# Hydrology Study

## Tentative Tract No. 20022

**NOT APPROVED**

By Osvaldo Roque at 8:04 am, Aug 23, 2019

FIGURE D-3

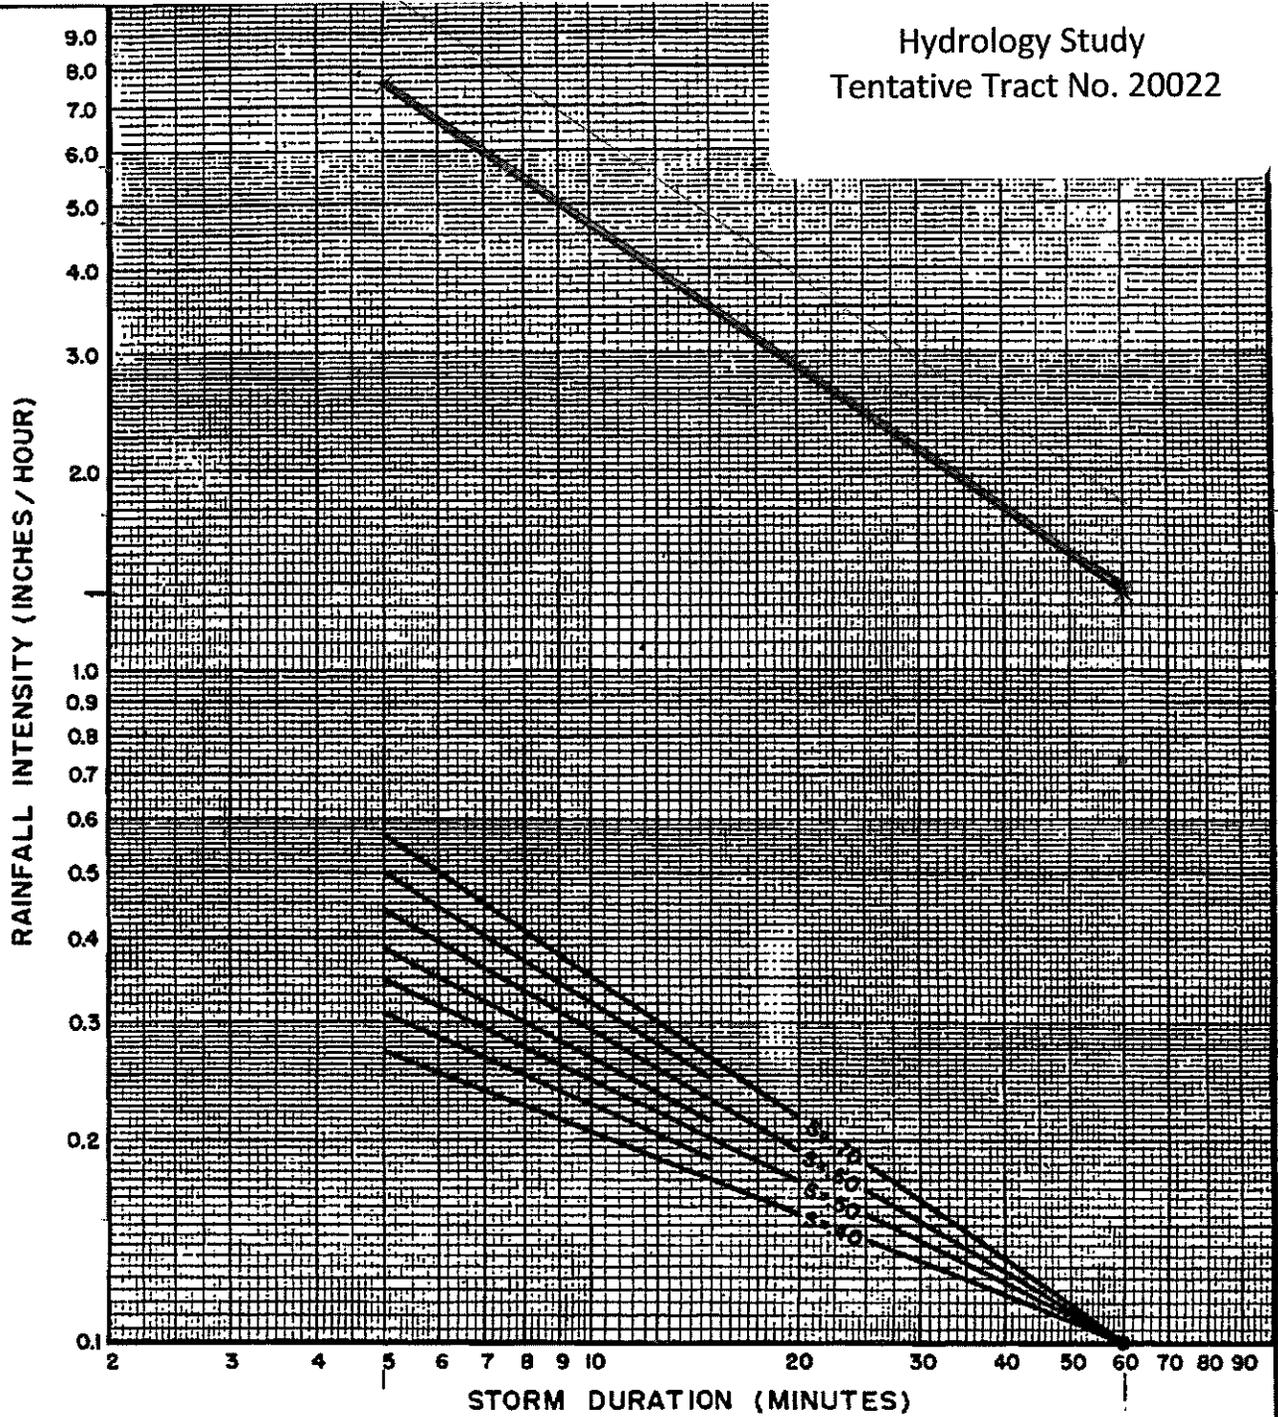
100yr-1hr storm analysis required for mitigation and easement sizing as described in hydrology manual.
